Proposal for revising para. 2.2.1 of Regulation ECE R112 Annex 6

Zhang Heng
P. R. China

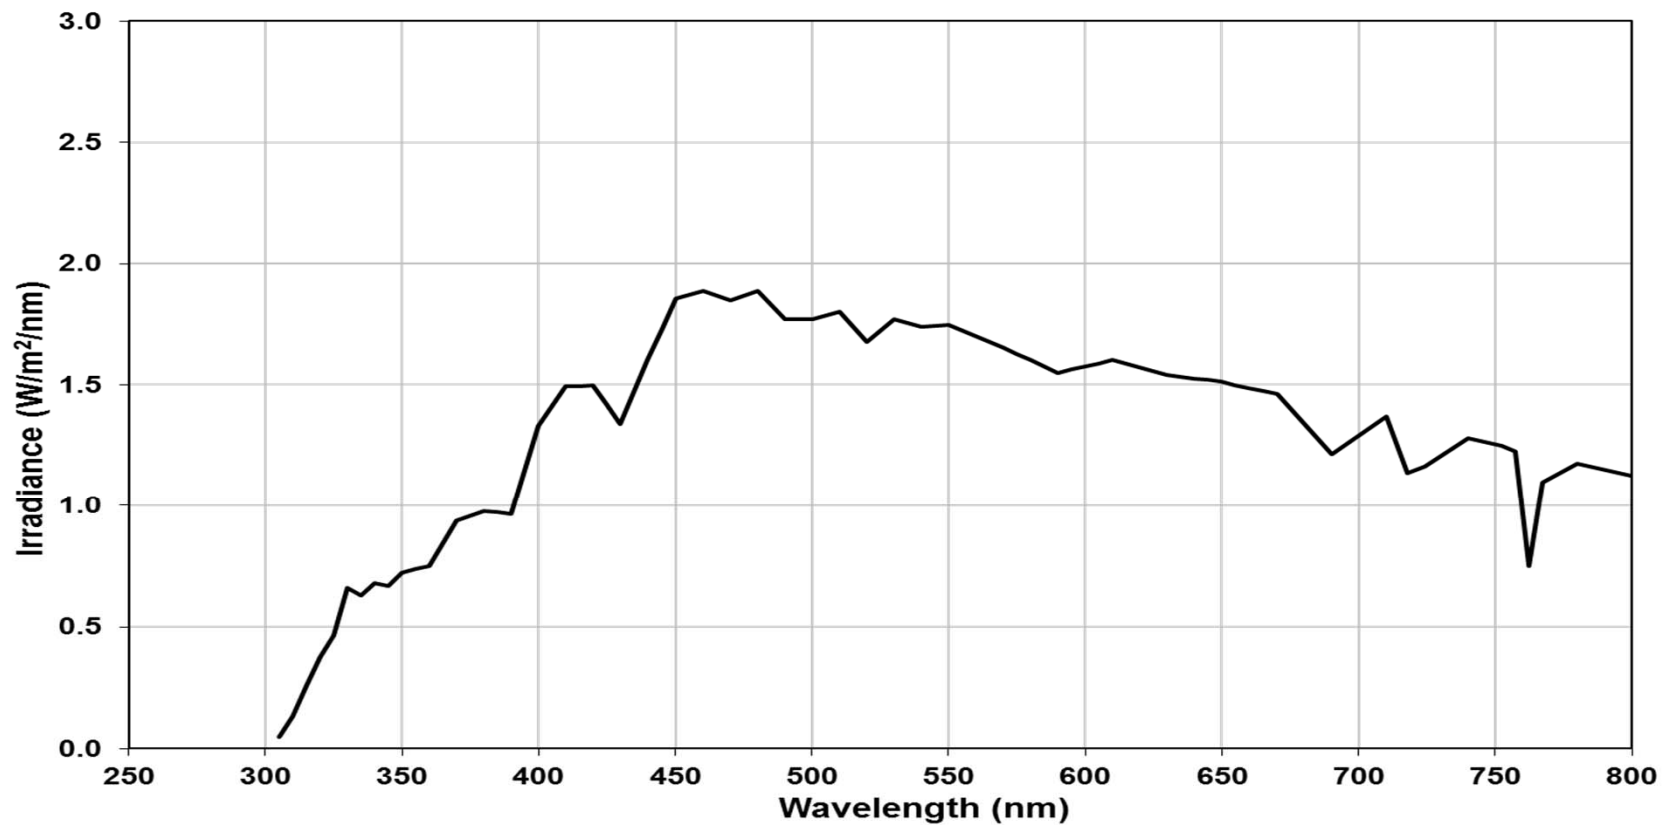
The spectral energy distribution of the light source is improperly described:

- Black body temperatures are useful for lighting sources and color matching, but do not accurately or sufficiently describe the sunlight spectrum
- Most current international weathering standards describe the spectral energy distribution of sunlight by referring to CIE Publication No. 85:1989, Table 4

Three new samples (lenses or samples of material) shall be exposed to radiation from a source having a spectral energy distribution similar to **daylight spectral energy distribution described in CIE Publication No. 85:1989, Table 4.**

SAE J2527-2004 FIGURE C2 (page 17)—DAYLIGHT FILTER VS. SUNLIGHT SPECTRAL POWER DISTRIBUTION

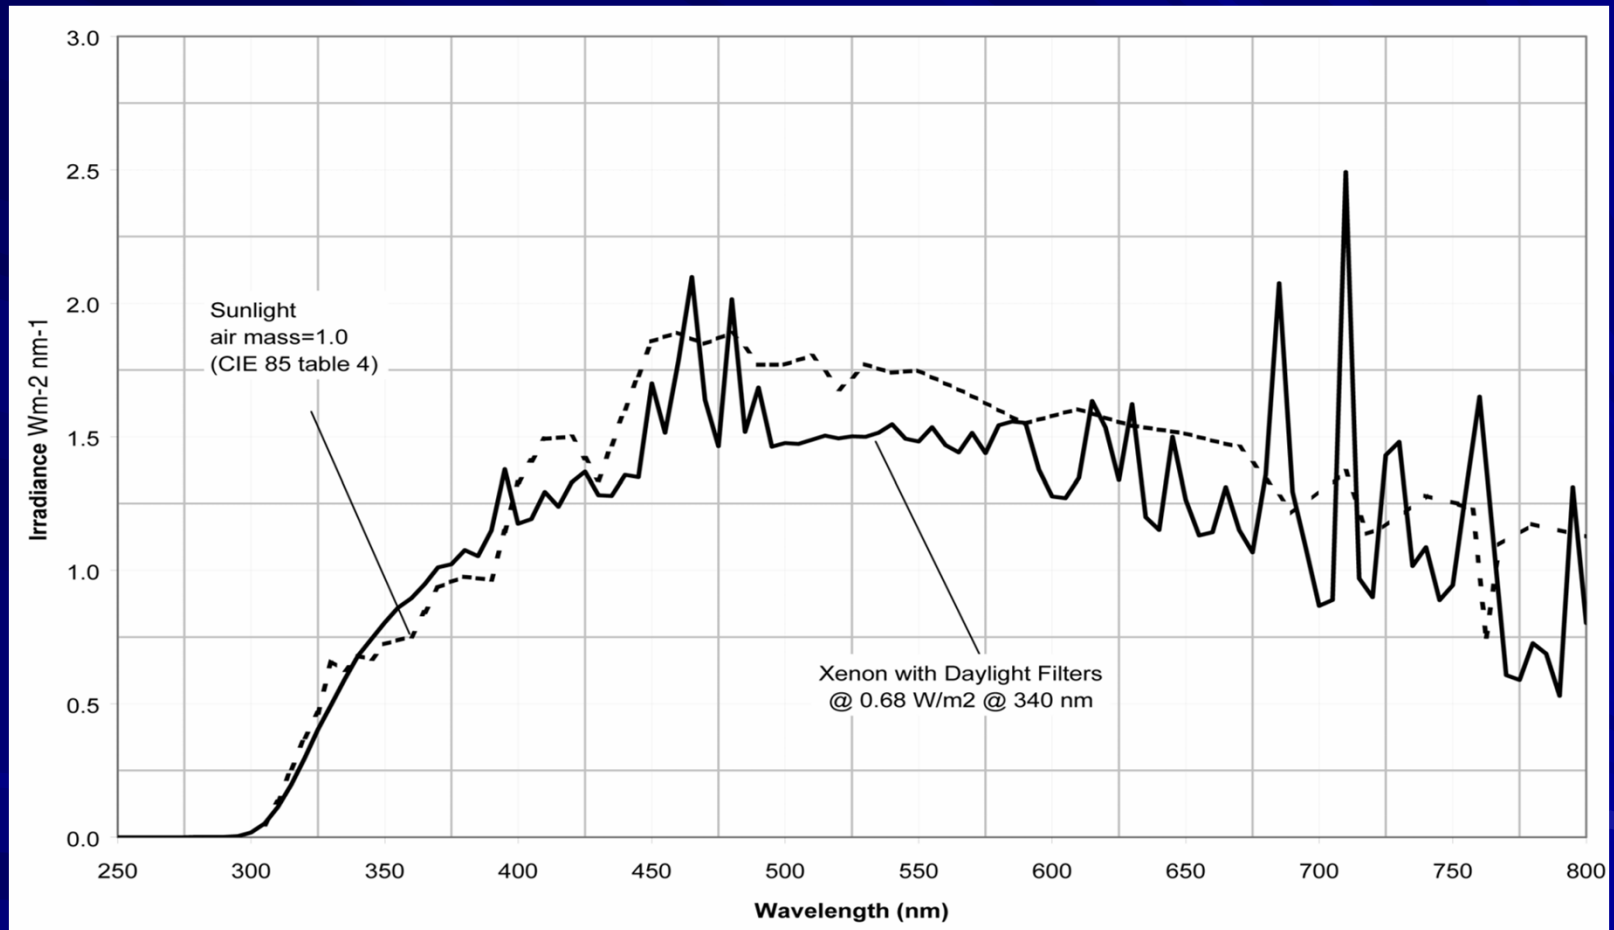
Problem #2: Justification

- Providing only the wavelength range does not sufficiently define the spectrum
 - It is important to accurately specify the proportions of wavelength ranges to match sunlight
 - If the proportions of UV radiation do not match sunlight, unrealistic degradation may occur
- This is accomplished by the use of appropriately designed “Daylight” optical filters

Appropriate filters shall be placed between the source and the samples so as to reduce as far as possible radiations with wave lengths smaller than 295 nm and greater than 2,500 nm, **and the minimum and maximum levels of the relative spectral irradiance in the UV wavelength range are given in Table 1.**
(add the green font)

Figure 1 Rotating Drum Xenon Arc Tester Cross Section

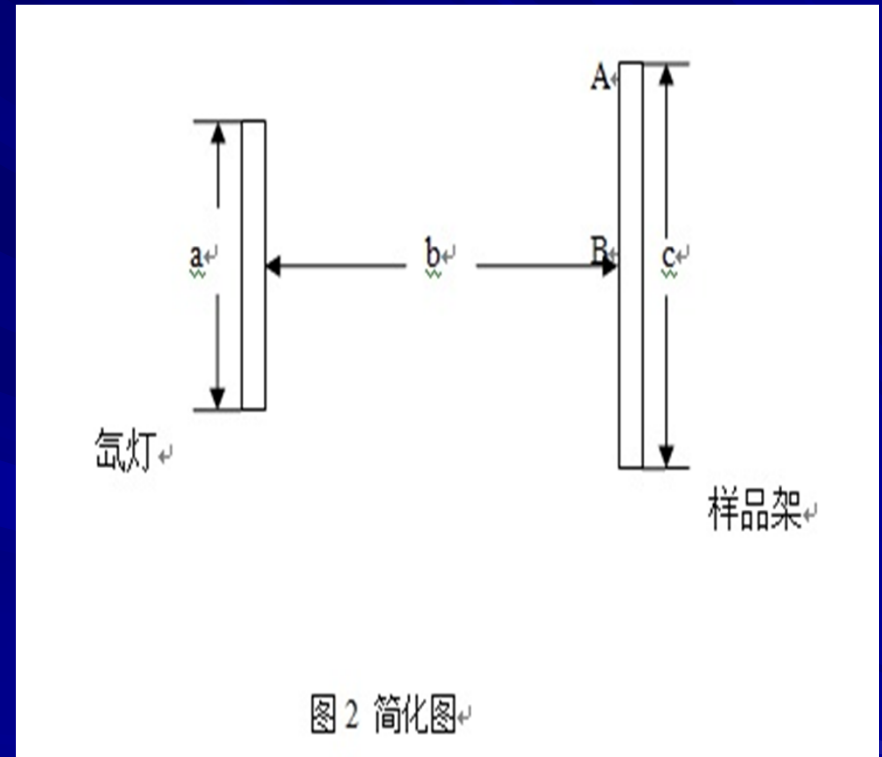
Exposure uniformity is not defined and hardware specific current wording violates international standards guidelines (e.g. ISO, ASTM, SAE)

- The terms “revolve” and “speed” are hardware based descriptions and do nothing to ensure exposure uniformity
- International standards (e.g. ISO 4892-2:2006) have solved this problem by specifying minimum uniformity

In order to ensure a regular exposure, **the irradiance at any position in the area used for specimen exposure shall be at least 80% of the maximum irradiance.**

Figure 3 horizontal axis : Distance of point B to point A (middle)
vertical axis : Ratio of Irradiance B vs. Irradiance A (middle)

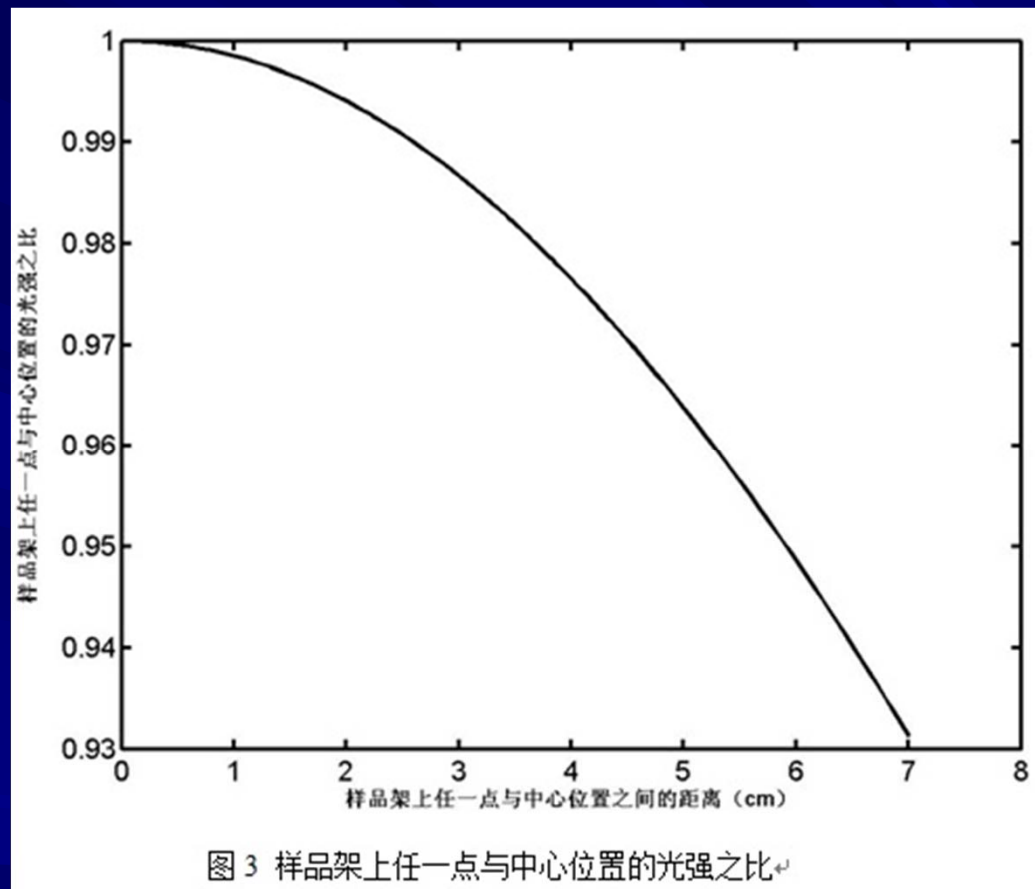
Note: the irradiance will be higher when the sample is closer to the middle.
